Wollongong Local Planning Panel Assessment Report | 16 October 2019

WLPP No.	Item No. 3
DA No.	DA-2019/595
Proposal	Residential - demolition of existing building and tree removals. Construction of multi-unit housing comprising of four (4) dwellings with one (1) level of basement carparking
Property	28 George Street, THIRROUL NSW 2515 Lot 28 DP 1099628
Applicant	Mr Marko Lisica
Responsible Team	Development Assessment & Certification – City Wide Planning Team (MB)

ASSESSMENT REPORT AND RECOMMENDATION

Ground Floor Unit 1 and 2

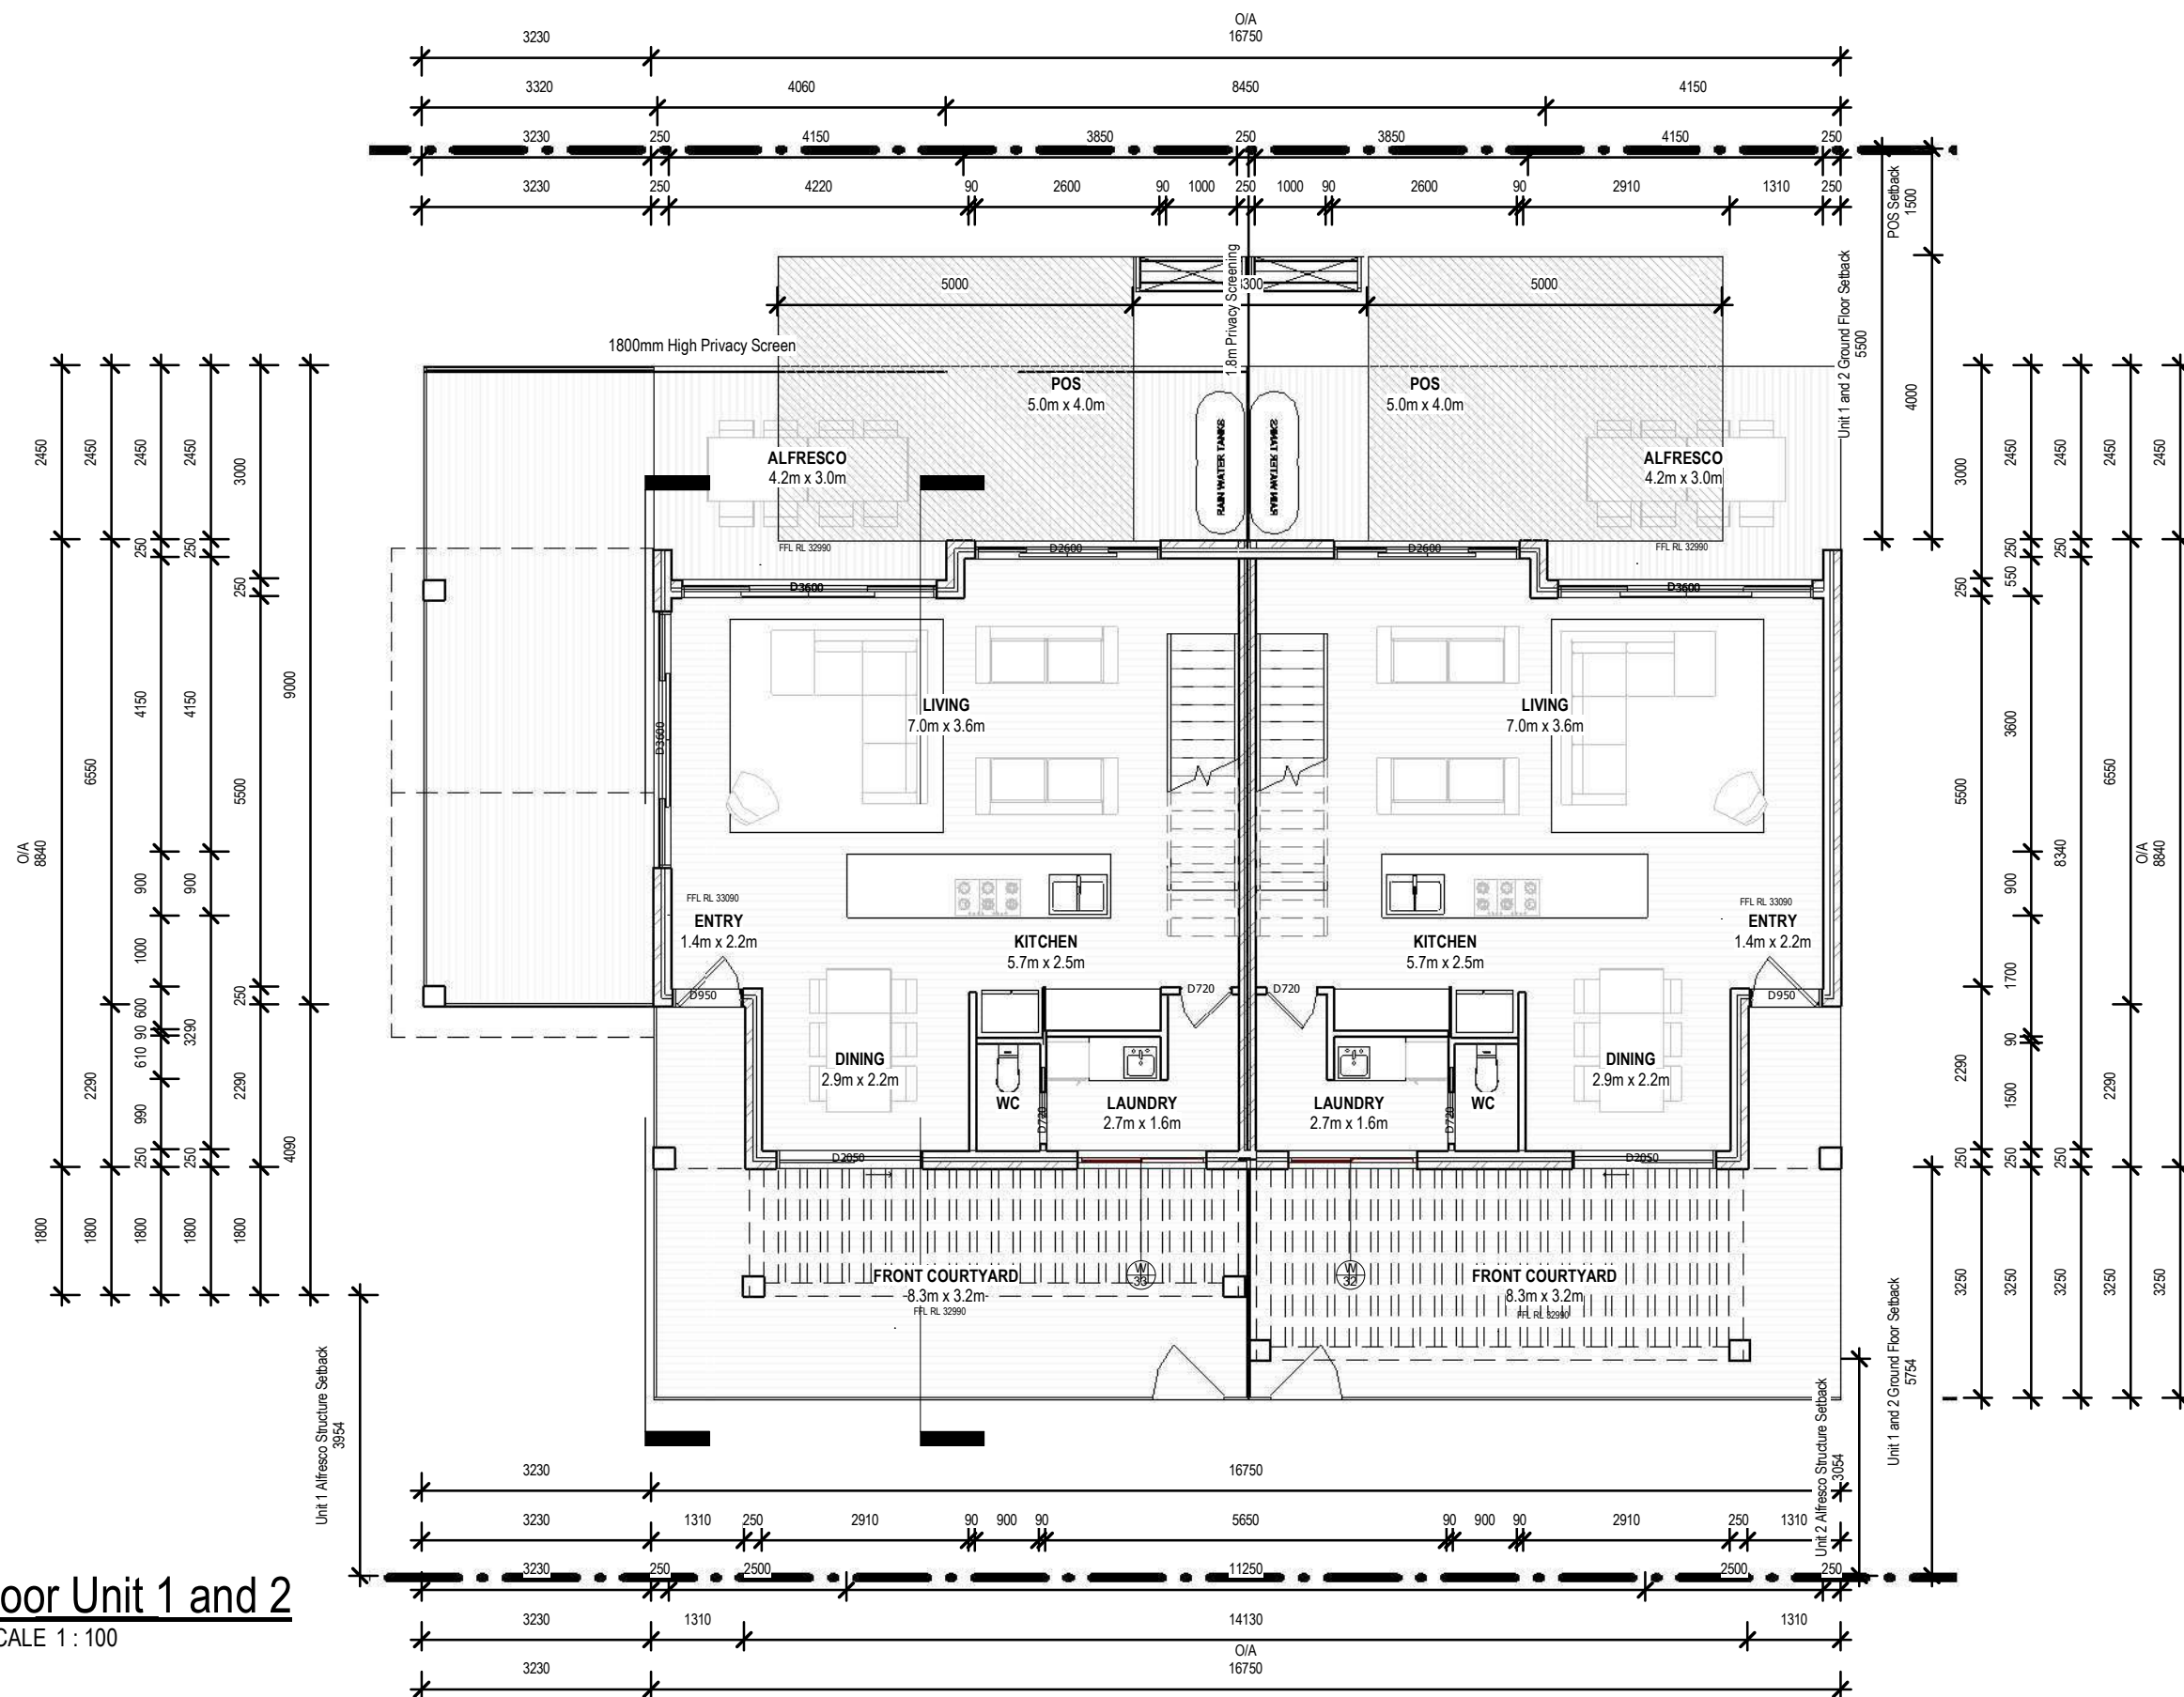
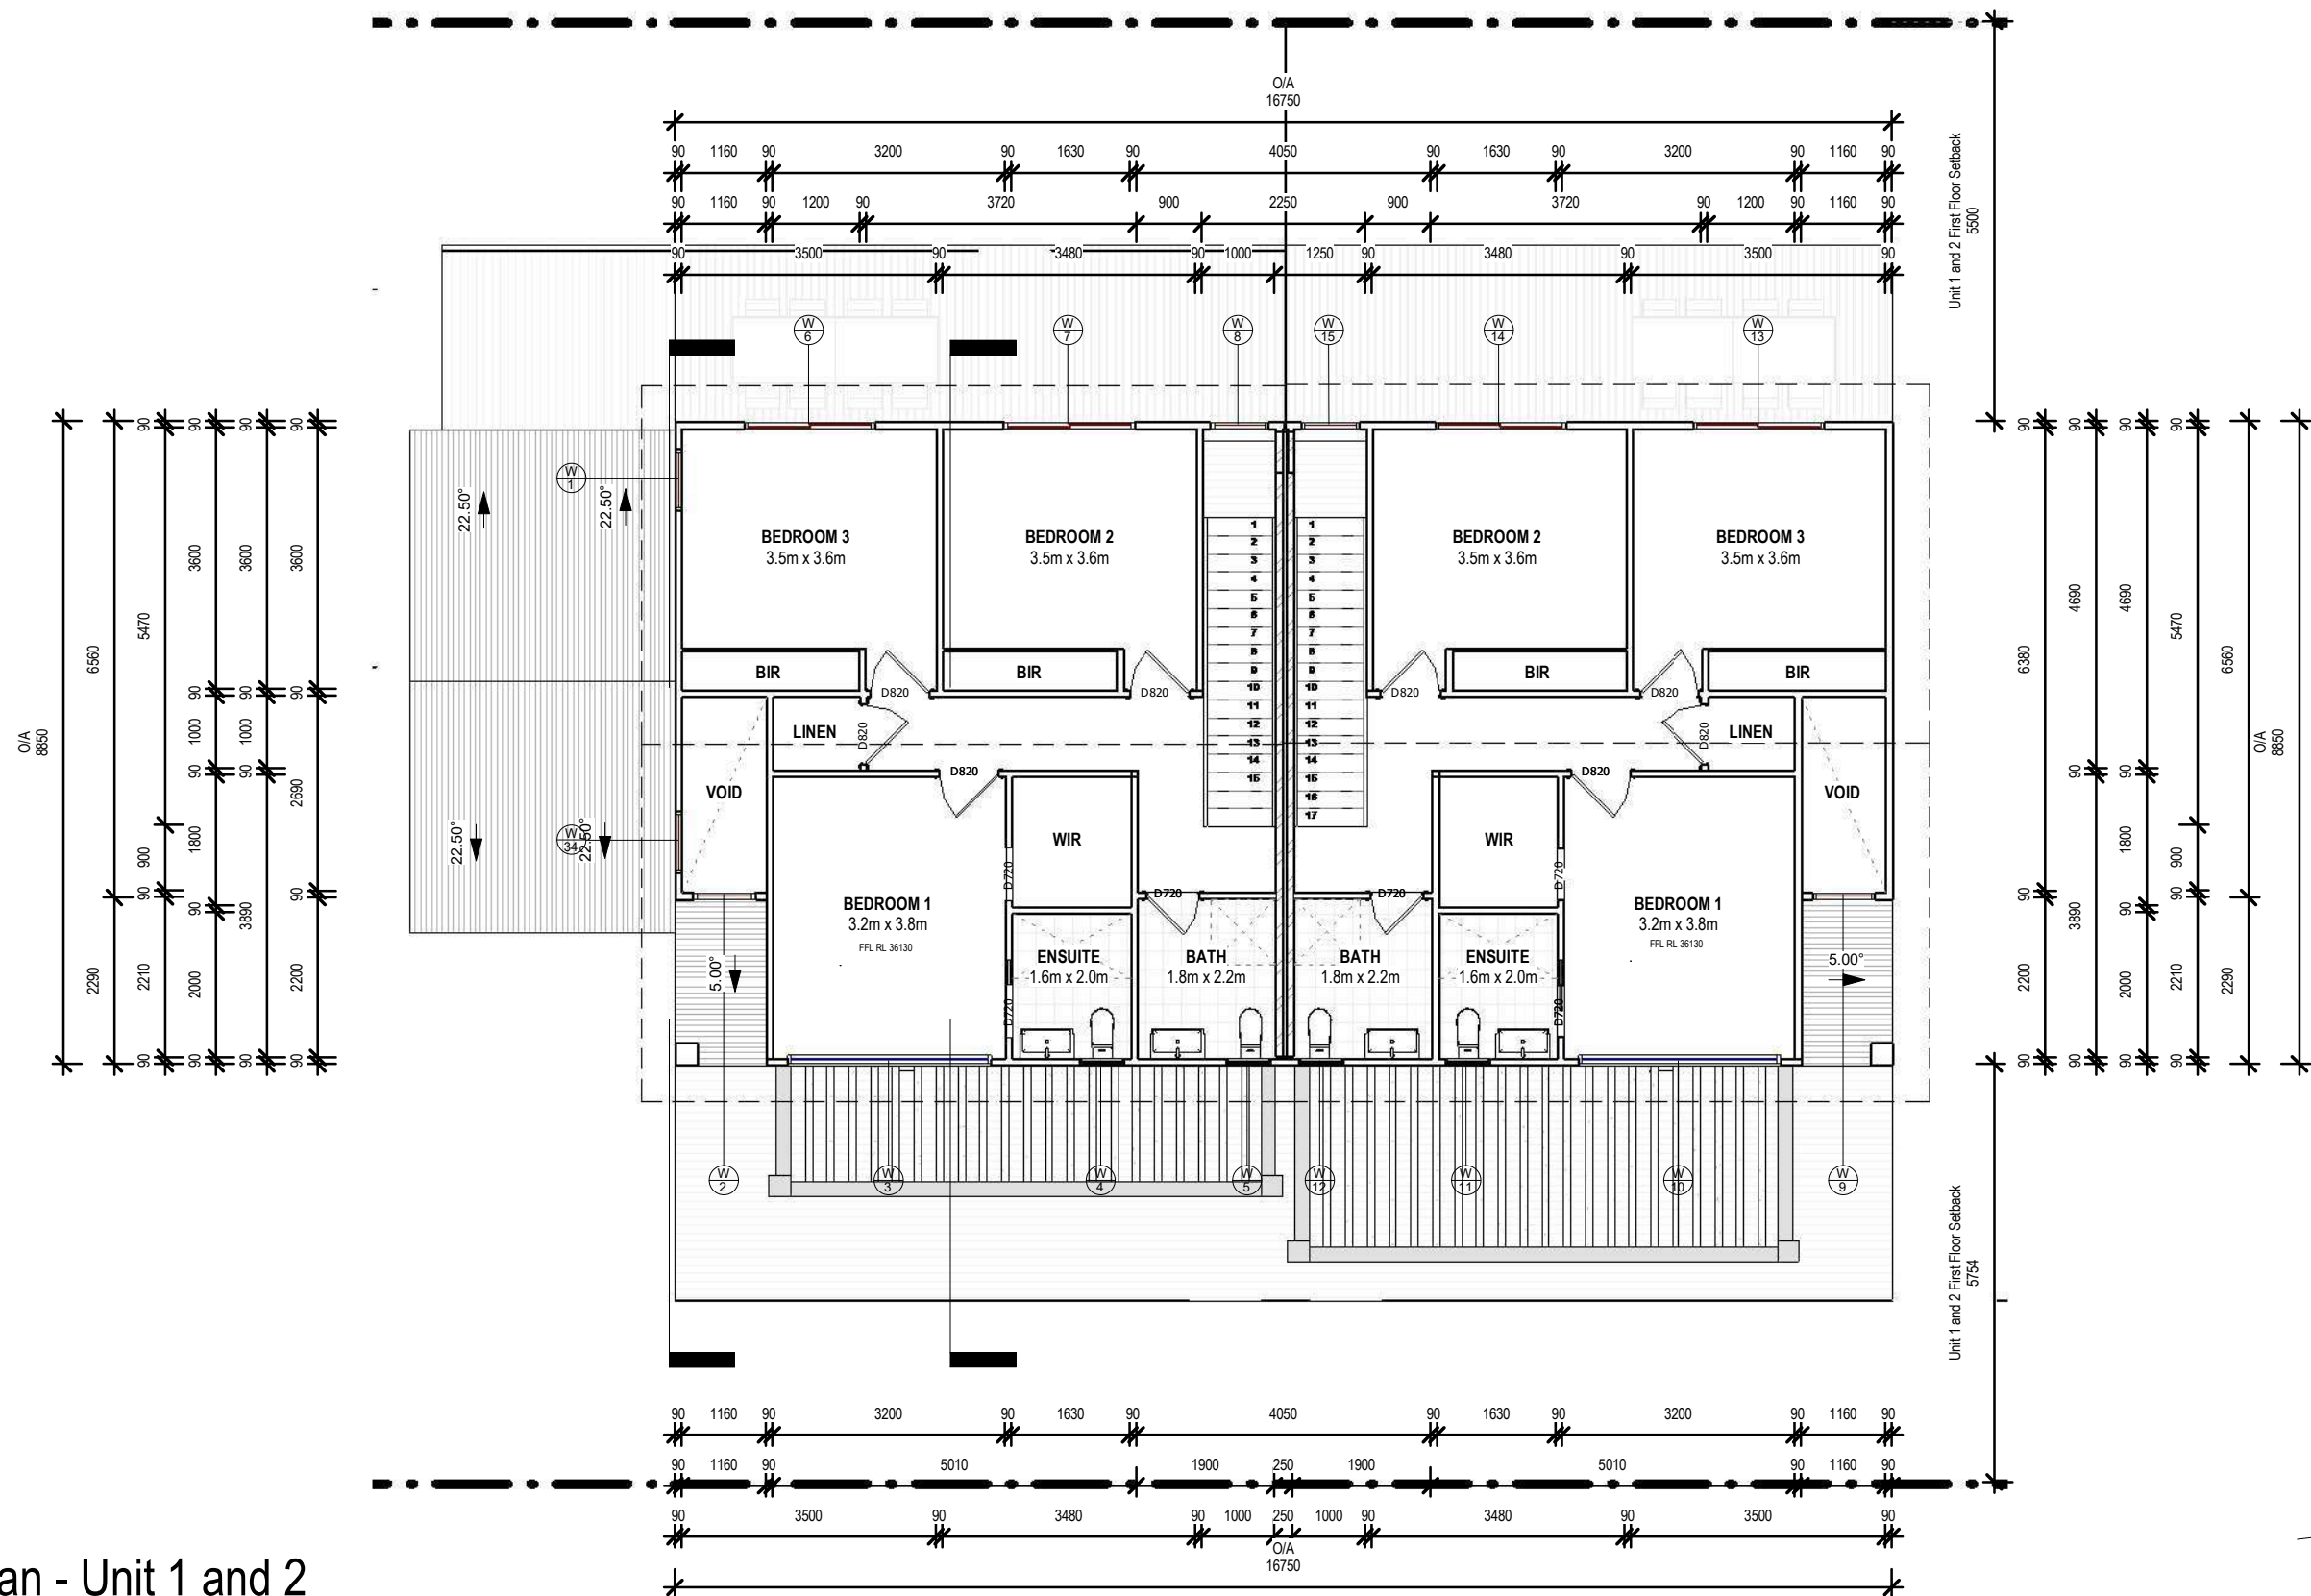
Units 1 and 3 both have areas of the POS and the front courtyard elevated (one metre) above natural ground level (at the southernmost end) which is considered to pose potential overlooking impacts to adjoining properties on both the eastern boundary and the western boundary. A 1.8m high privacy screen (horizontal angled slats to provide sunlight penetration) has been proposed on the western side of the elevated private open space to ensure view lines are directed away from the neighbouring property to the west. A terrace/courtyard is proposed on the eastern side of both Units 1 and 3. The courtyard includes a pergola and neighbouring trees do provide screening;

however, it is considered that the extent of the terrace particularly for Unit 3, which is larger could be minimised or lowered. This matter is outlined at **Attachment 3**.

A 1.8m high privacy screen (horizontal angled slats to provide sunlight penetration) has been proposed along the private open space on the western boundary for both units. In this case, it is not considered that a privacy screen is adequate to mitigate potential impacts and design changes are required. This could be achieved by:

A terrace/courtyard is also proposed on the eastern side of both Units 1 and 3. The courtyard is partially covered with a pergola and trees on the neighbouring property will provide screening at this point in time; however, it is considered that the extent of the terrace particularly for Unit 3 should be minimised or lowered. This could be achieved by:

- Reducing the size of the front courtyard at the southern end to create a screened walkway for Unit 3 and,
- Removal of access to the parapet from Dwelling 3 or the extension of the planter box to remove the ability for overlooking from the parapet **or**,
- Removal of the proposed front courtyard to Units 1 and 3

Amended plans should be provided addressing the above.
